RESOLUTION MSC.205(81)
(adopted on 18 May 2006)

**ADOPTION OF AMENDMENTS TO THE INTERNATIONAL MARITIME
DANGEROUS GOODS (IMDG) CODE**

**AMENDMENTS TO THE INTERNATIONAL MARITIME DANGEROUS GOODS
(IMDG) CODE (RESOLUTION MSC.122(75))**

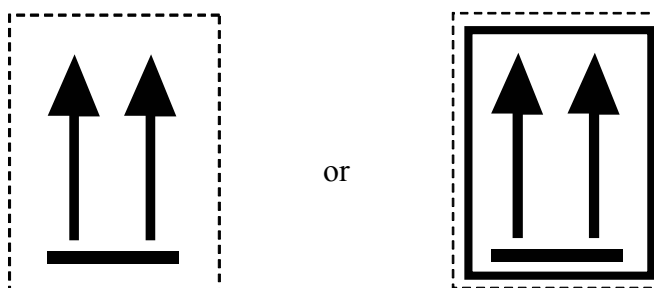
- 5.2.1.4 and 5.2.2.1.7 Add “and large packagings” after “capacity”.
- 5.2.1.5.4.3 Amend the end of the sentence to read as follows: “...origin of design and either the name of the manufacturer or other identification of the packaging specified by the competent authority of the country of origin of design.”.
- 5.2.1.5.8 Add the following new paragraph:
- “5.2.1.5.8 In case of international transport of packages requiring competent authority design or shipment approval, for which different approval types apply in the different countries concerned, marking shall be in accordance with the certificate of the country of origin of the design.”.
- 5.2.1.7 Add the following new paragraphs:
- “5.2.1.7 Except as provided in 5.2.1.7.1:

- combination packagings having inner packagings containing liquid dangerous goods;
- single packagings fitted with vents; and
- open cryogenic receptacles intended for the transport of refrigerated liquefied gases,

shall be legibly marked with package orientation arrows which are similar to the illustration shown below or with those meeting the specifications of ISO 780:1985. The orientation arrows shall appear on two opposite vertical sides of the package with the arrows pointing in the correct upright direction. They shall be rectangular and of a size that is clearly visible commensurate with the size of the package. Depicting a rectangular border around the arrows is optional.

Two black or red arrows on white or suitable contrasting background. The rectangular border is optional

Add label No.5.2(b) and the text under the label with the following:

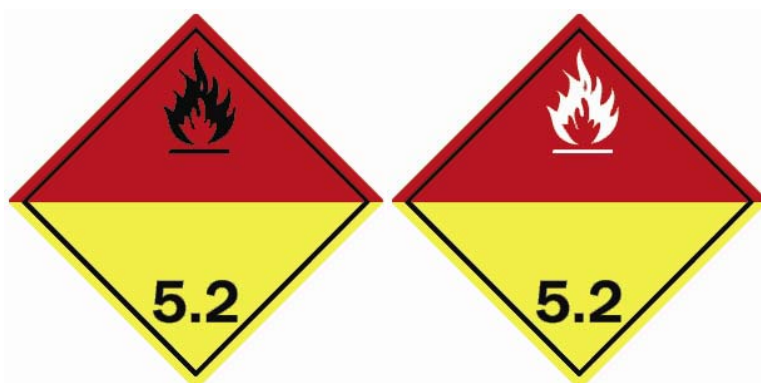
Retain the existing label No.5.2 and replace the text below it by:

and add a footnote to read: “* May be used until 1 January 2011.”.

“(No.5.2(b))

Figure “5.2” in bottom corner”.
